# Panel Submission – Part B

## Planning Scheme Amendment C131latr Flood Overlays Update

Latrobe City Council and West Gippsland Catchment  
Management Authority

Circulated 8 July 2024

Figure 10: Re-Exhibition Version of Proposed Overlays on Paul Street and Le Grange

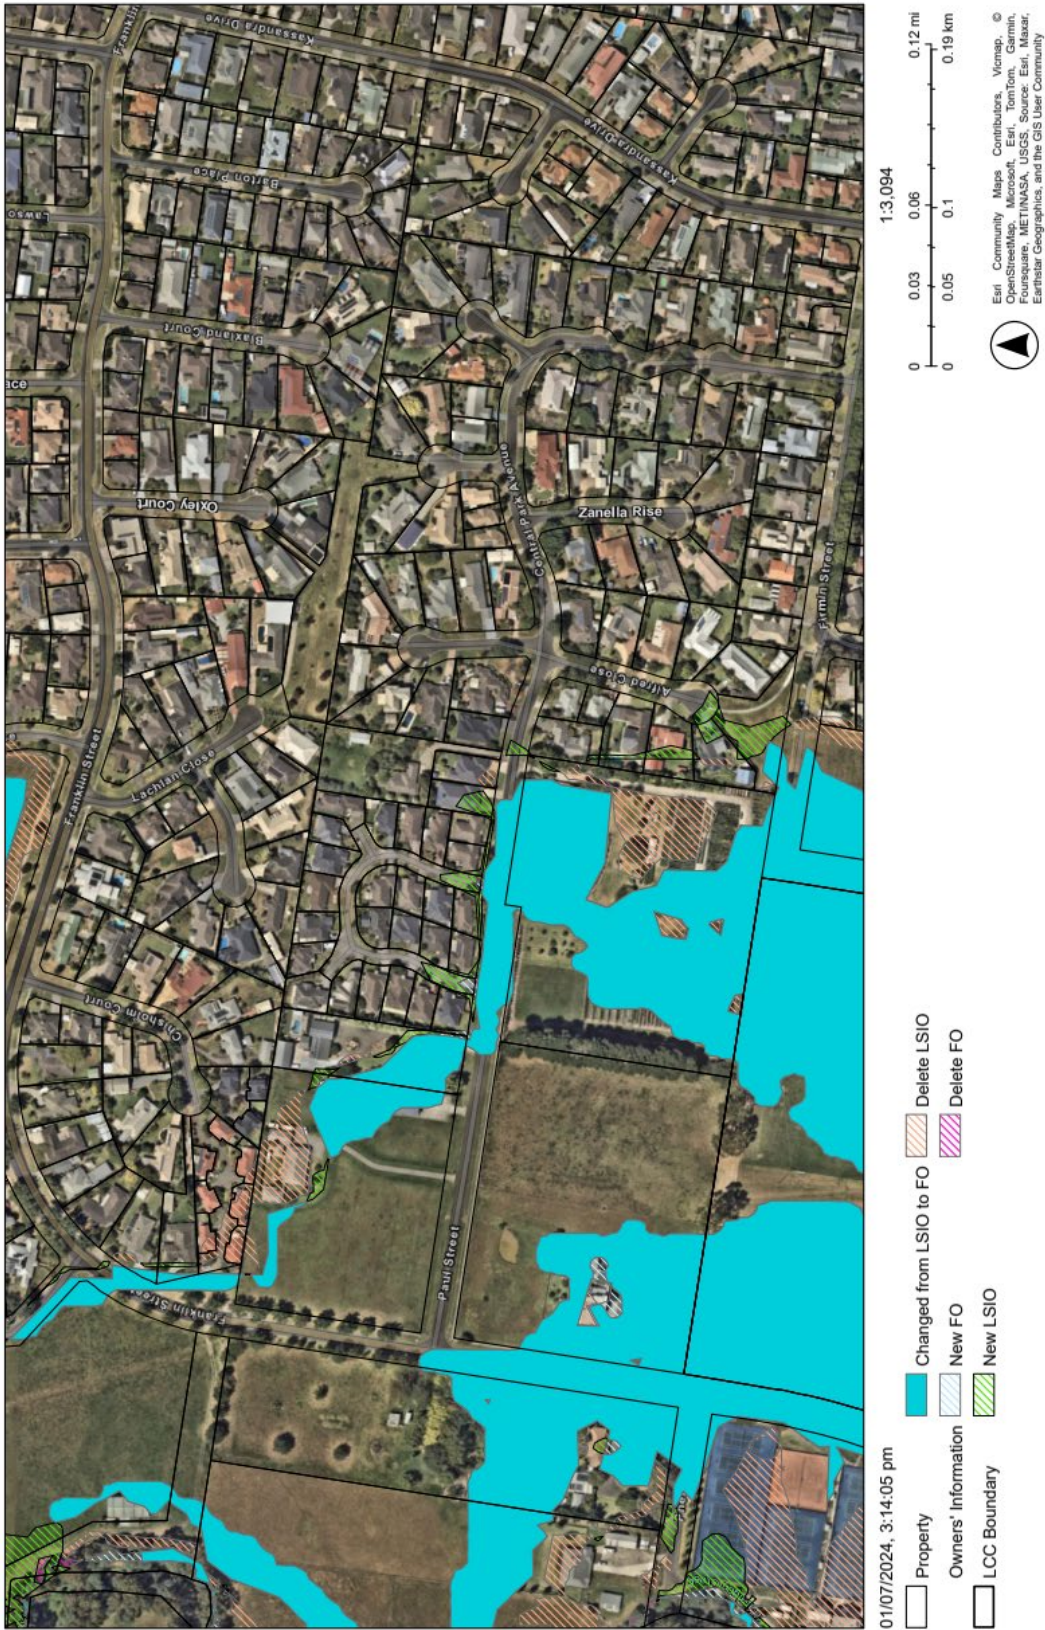
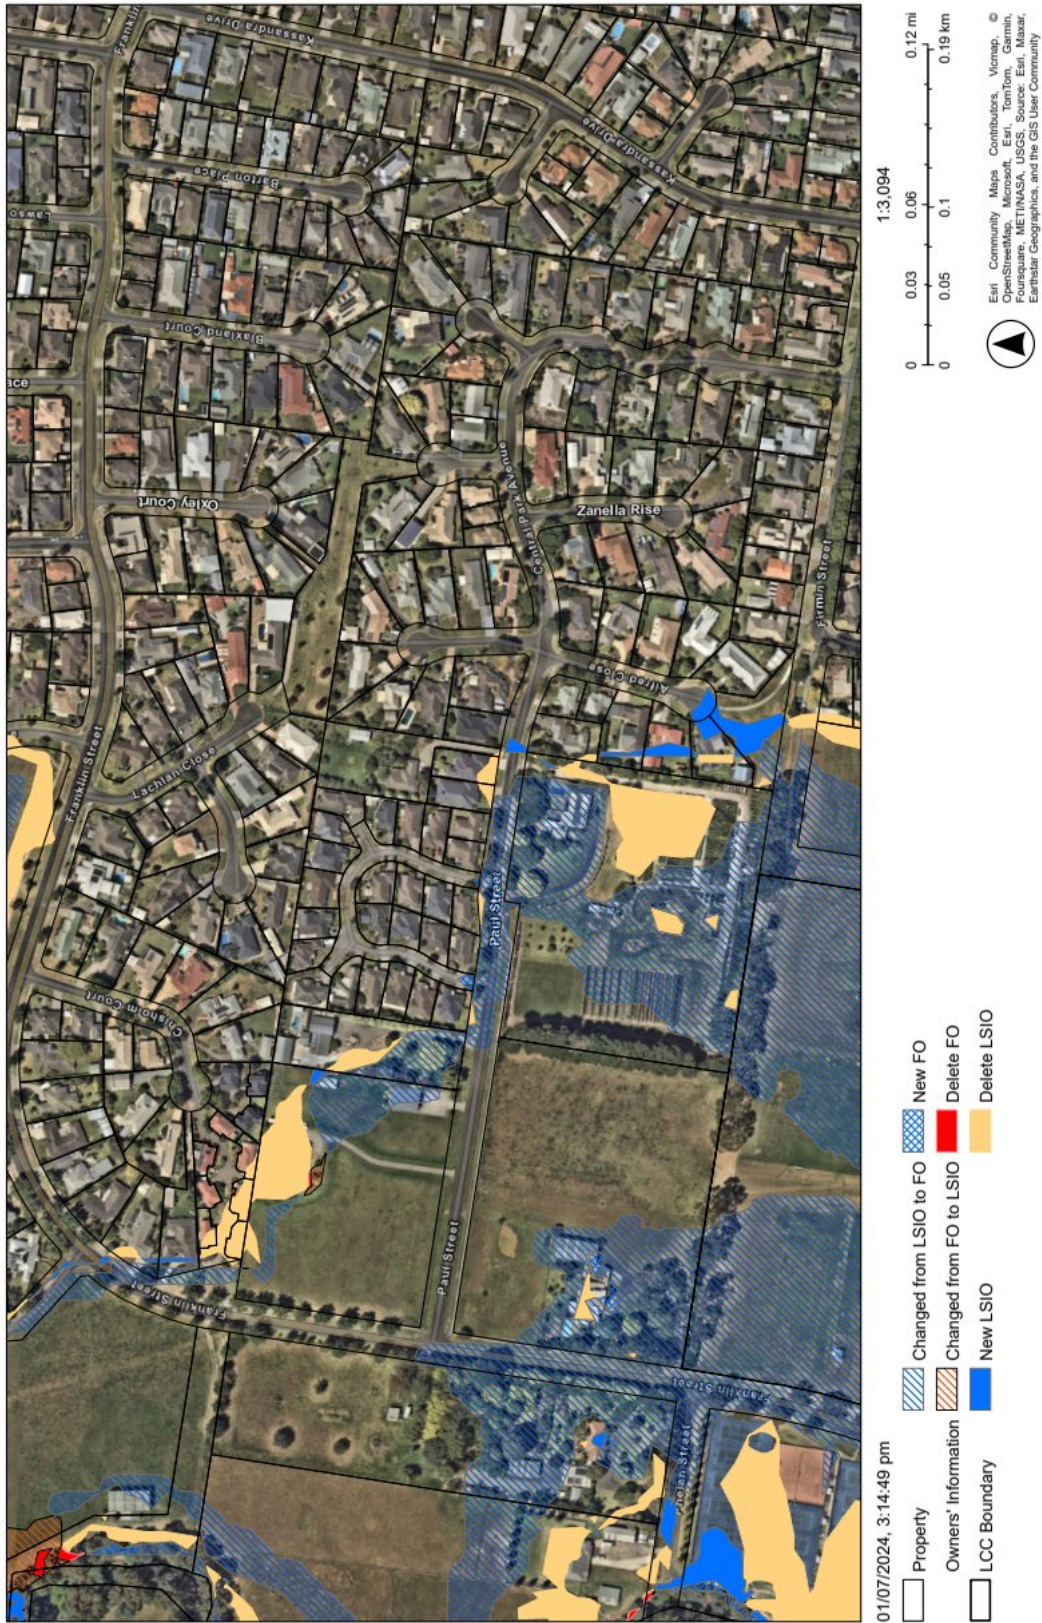
133. Several enquiries were made about the identified flood levels and whether they matched the local topography along Paul Street and Le Grange, Traralgon.
134. In response to enquiries made and submission 76, WGCMA undertook inspections and surveyed land levels in the area. The surveyed levels were then compared to the newest lidar (2019) available at this location. It was determined that land levels had changed since the flood study was completed and the overlay extents were adjusted based on new lidar information to reflect the new land levels.
135. The proposed changes in the Day 1 version compared to the Re-exhibited version are shown in Figure 10 and Figure 11.

137. Council proposes to amend maps 48LSIO-FO, 49LSIO-FO, and 50LSIO-FO in response to submissions and the subsequent reviews that were undertaken by WGCMA.

Figure 13: Current Overlays at Lot 33 Bradman Boulevard, Traralgon

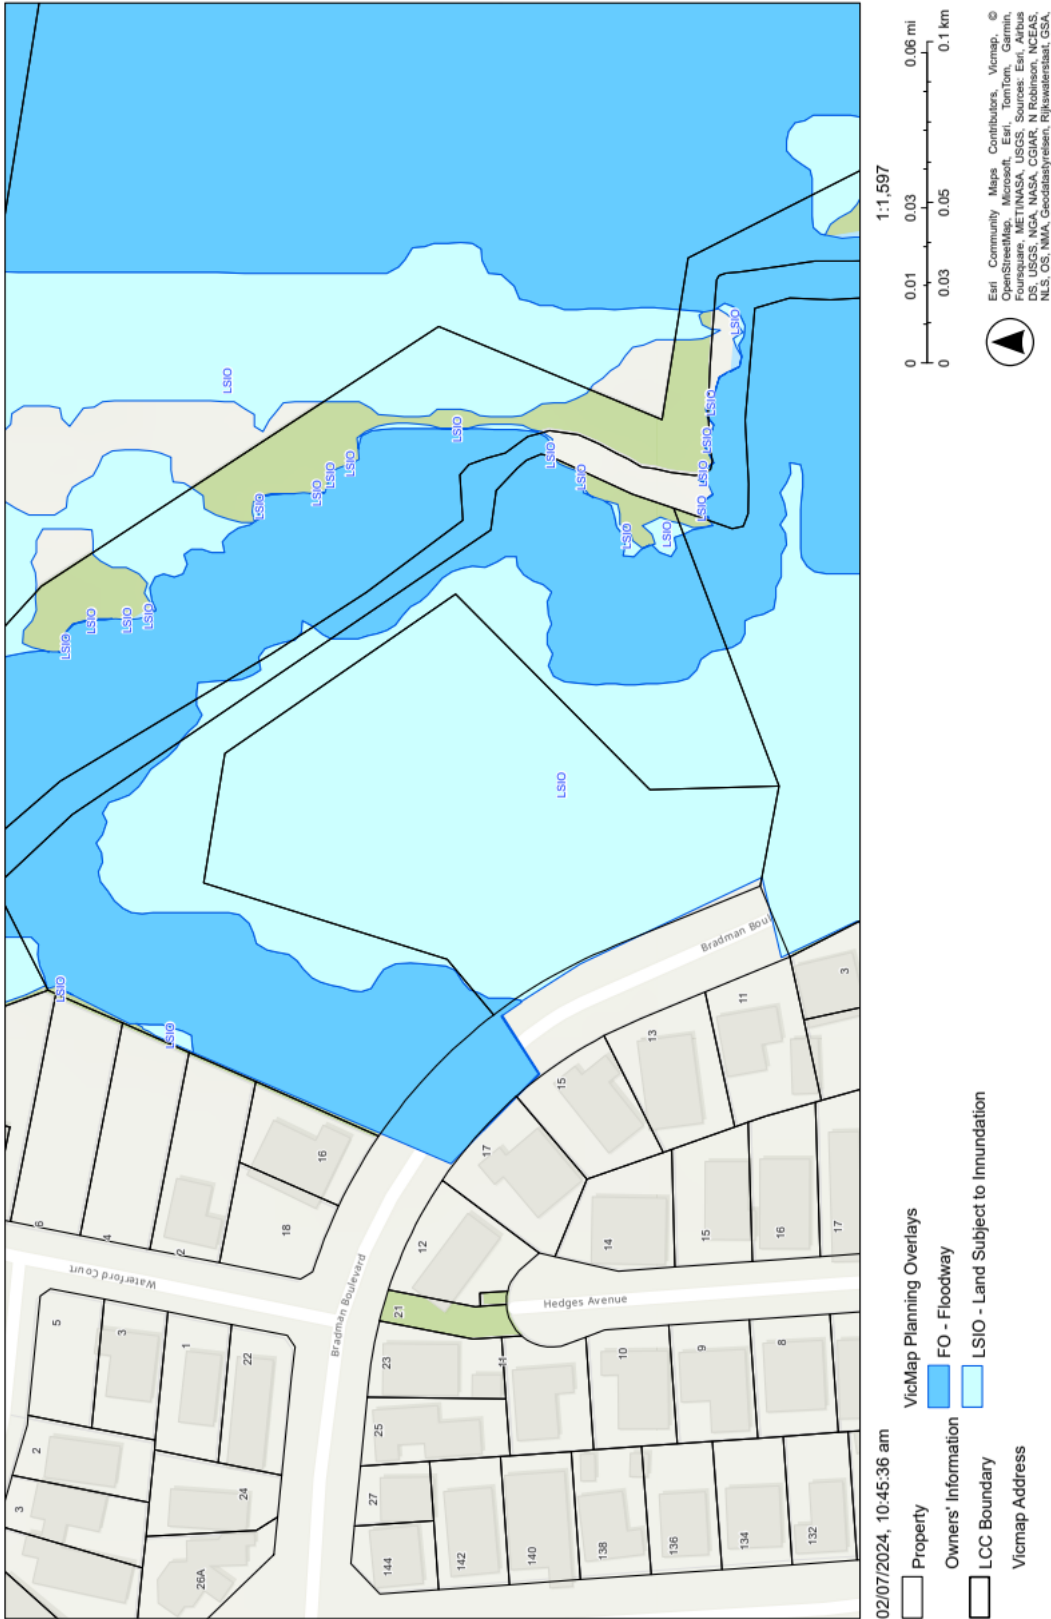
164. The LSIO was introduced on the property as a result of Amendment C9. Amendment C9 sought to update the flood extent mapping as a result of the *Traralgon Creek Floodplain Management Strategy* undertaken in 2000, as shown in Figure 13.

166. The overlays on the site are proposed to be changed from LSIO to FO. As shown in Figure 14.

Figure 15: 1% Annual Exceedance Probability Flood Depth

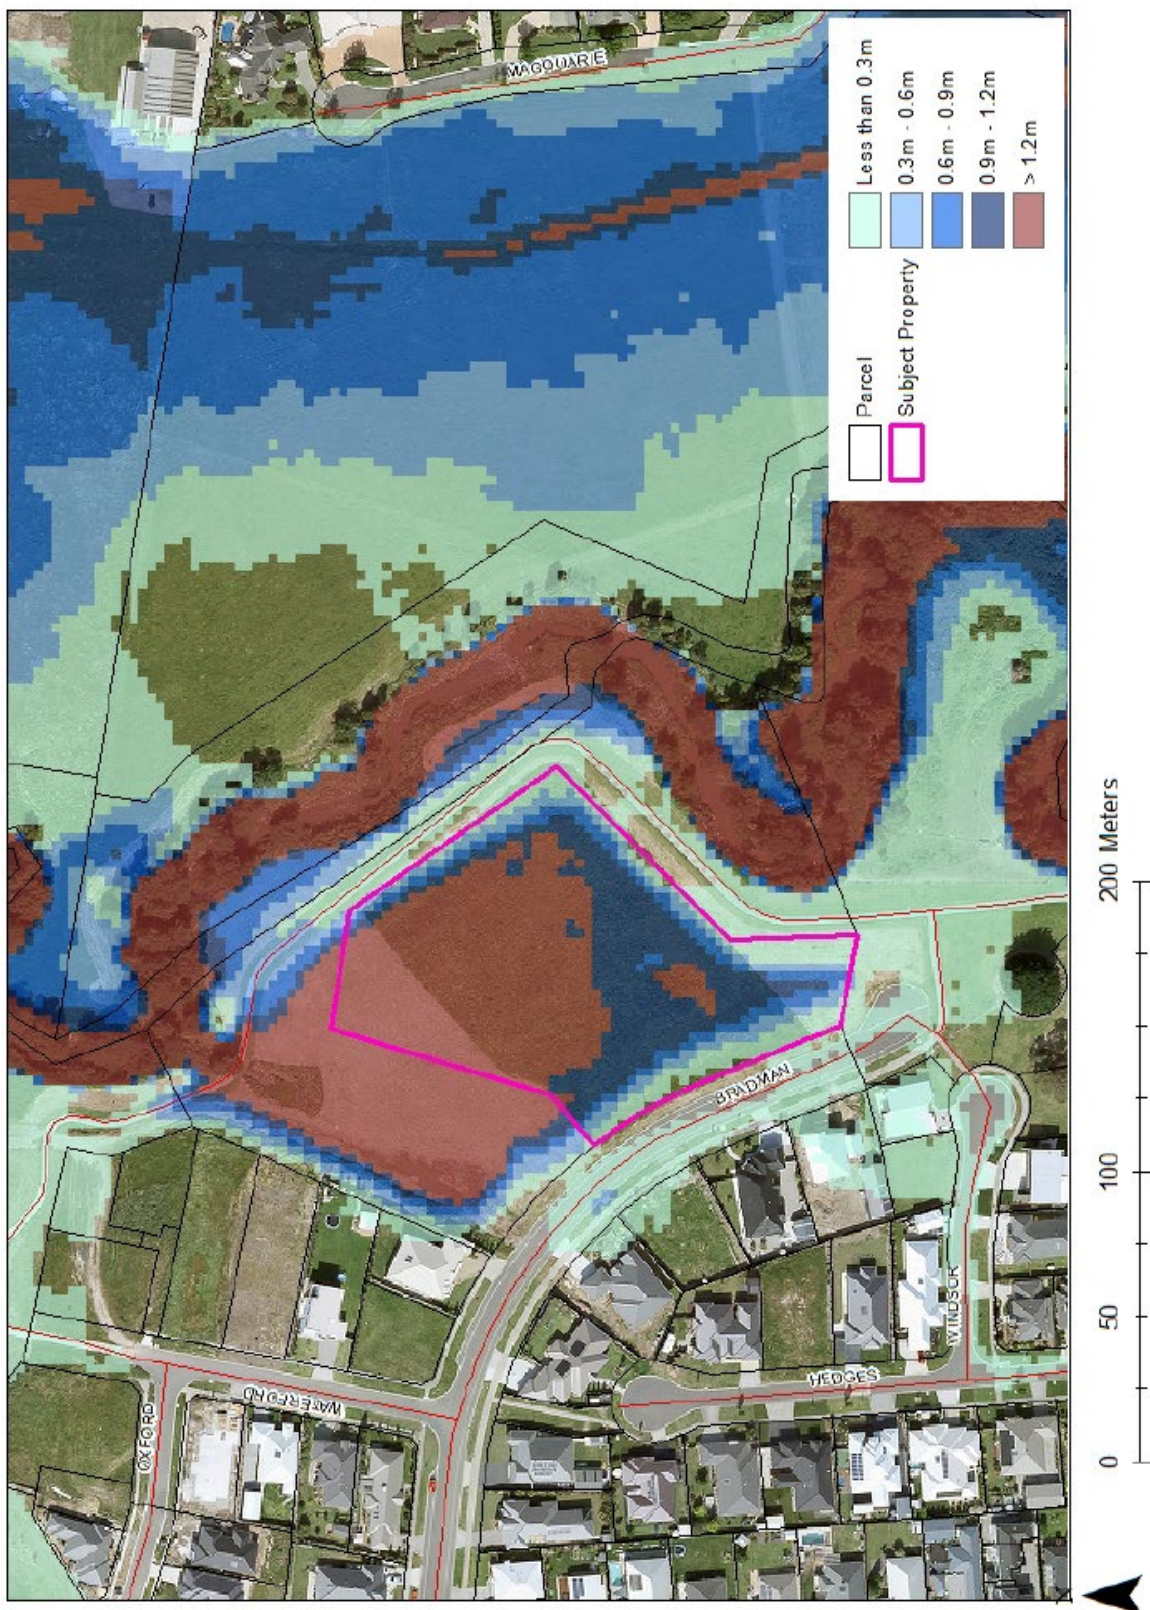
167. The West Gippsland Catchment Management Authority's *Flood Guidelines - Guidelines for development in flood prone areas* (2020) state that where flood depths during a 1% AEP flood event is likely to exceed 0.3 metres over the development site or 0.3 metres over the vehicle route from the property, a proposal that seeks to intensify development through the creation of additional lots or dwellings is not supported as it would increase the amount of people and property exposed to the flood hazard.
168. The proposed application of the flood overlays is consistent with this methodology.
169. The *Traralgon Flood Study 2016* indicates that the flood depths on the majority of the property will have a depth of more than 0.8m in a 1%AEP flood event, as shown in Figure 15.

Figure 16: Amendment C24 - Glengarry Town Structure Plan

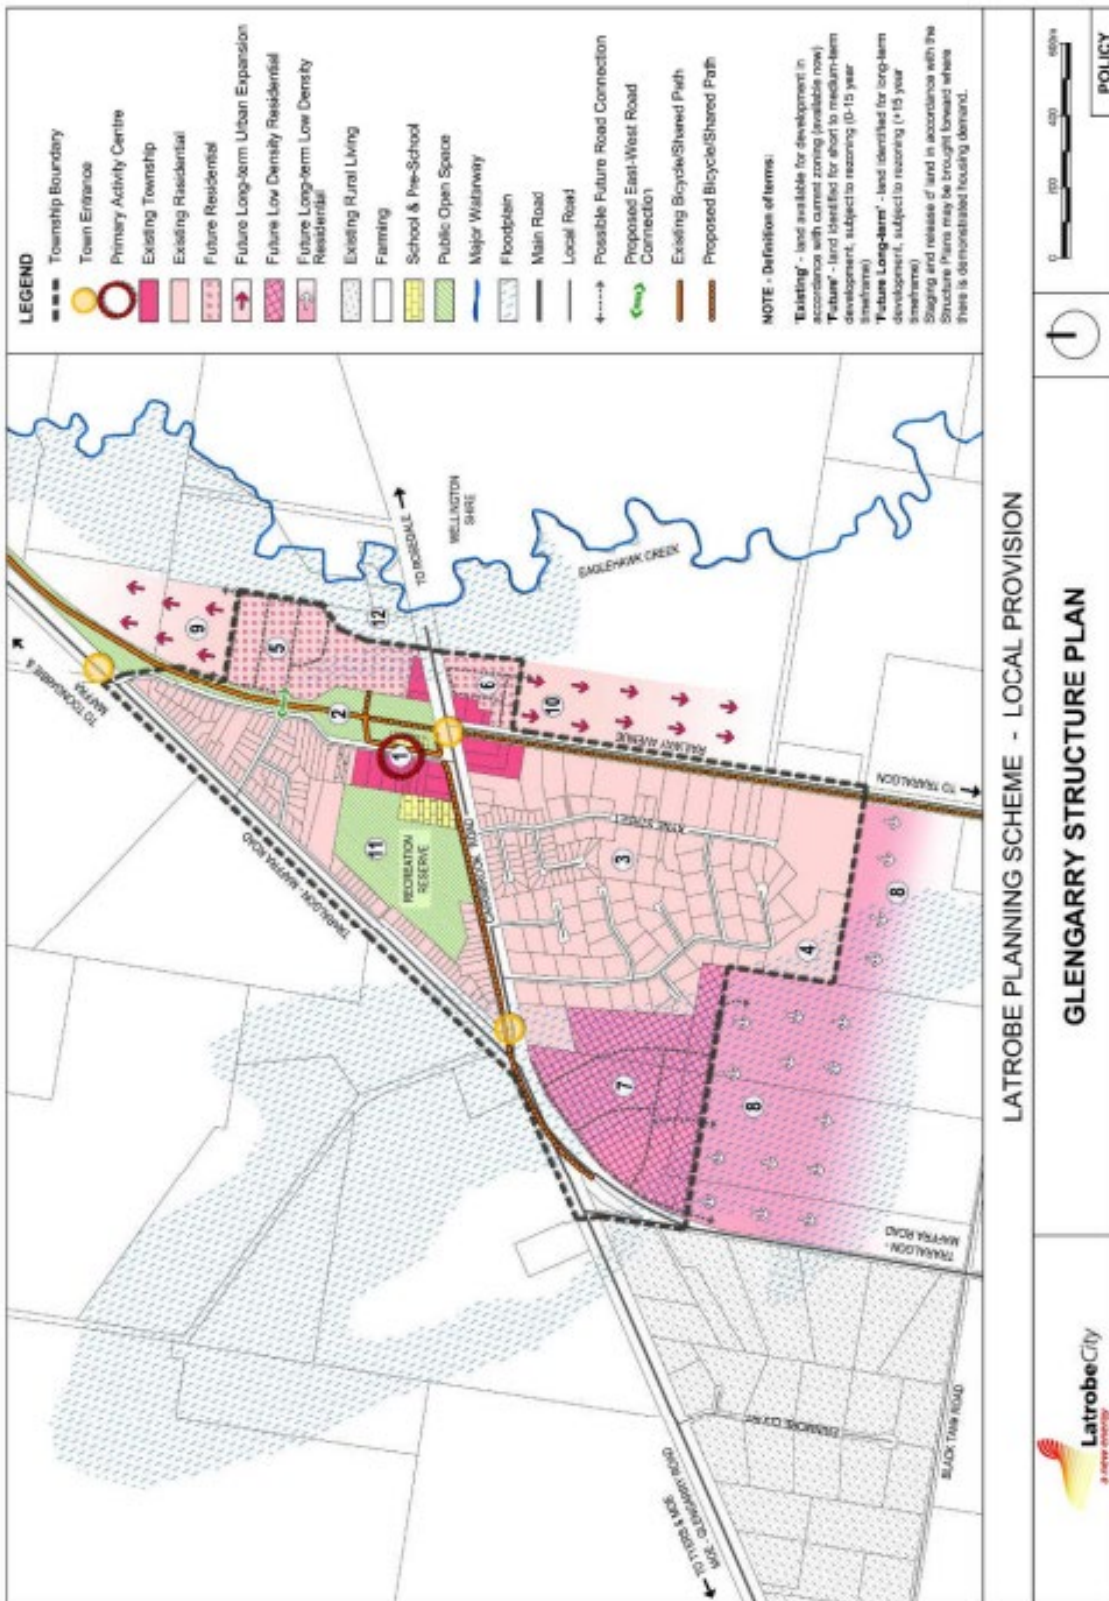
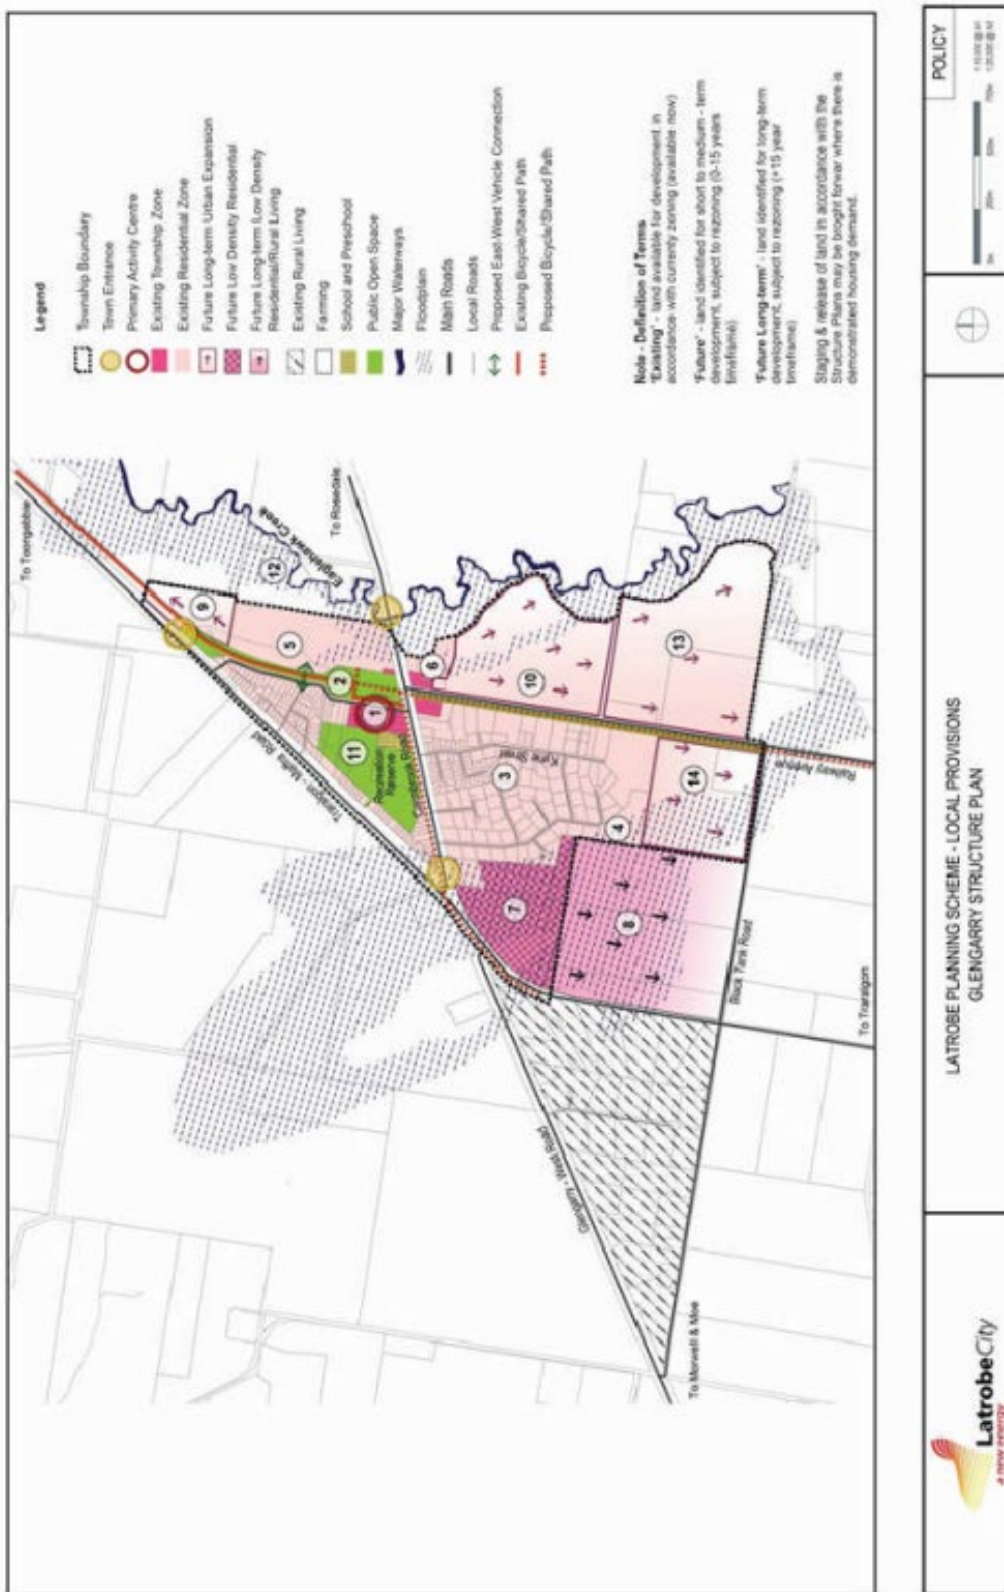
- 190. Submissions 27 and 28 object to the ‘future residential’ status on their properties in the Glengarry Town Structure Plan in Clause 11.01-1L.
- 191. The Glengarry Town Structure Plan was introduced into the Latrobe Planning Scheme on 10 February 2011 through Amendment C24.

192. Submitter 28's property was first identified as 'Possible Future Long-term Low Density Residential' (Area 8 in the Glengarry Town Structure Plan – Amendment C24 version) in Amendment C24 and was notified at the time of the Amendment as seen in Figure 16. This designation has remained unchanged since the implementation of Amendment C24.

193. The Glengarry Town Structure plan was then amended to include submitter 27's property through Amendment C87 Part 3 (Traralgon Growth Areas Review) which was gazetted on 10 August 2017, as shown in Figure 17 (Area 13 in the Glengarry Town Structure Plan Amendment C87 Part 3 version).

197. As the Glengarry Town Structure Plan in Clause 11.01-1L has the strategy to “*Encourage development in GTSP Areas 1, 2, 3 and 4 that is sensitive to the Eaglehawk Creek environment and floodplains.*” The extent of the flood overlays is proposed to be amended in the Glengarry Town Structure Plan to ensure accuracy and consistency with the proposed extent of the overlays in order to meet this strategy. No other changes are proposed.
